SIL 694

Service Information Letter

Units Affected: AT37, AT41, AT48 M/P/S units with GX or GY in the serial number
(Example 0717GX0253 or 0717GY128. If GH or GV is in serial number,
it is NOT affected by this SIL. See attached list)

Articulating Arm Drain Holes

Figure 1 — Articulating Arm

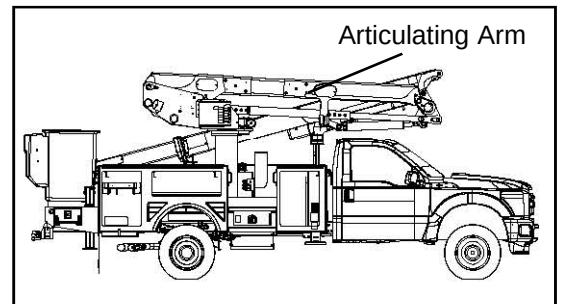
Altec found that some drain holes in the articulating arm had been filled with sealant instead of being left open to the air.

1. Position the unit on a level surface, apply the parking brake and chock the wheels. The inspection can be done with the boom stowed in the boom rest.
2. Inspect the articulating arm (refer to Figure 1) for four drain holes on the bottom of the arm. Look to see if the holes are plugged with sealant. Remove any sealant or contaminants that seal the holes using a $\frac{5}{16}$ " drill bit so all holes are open.
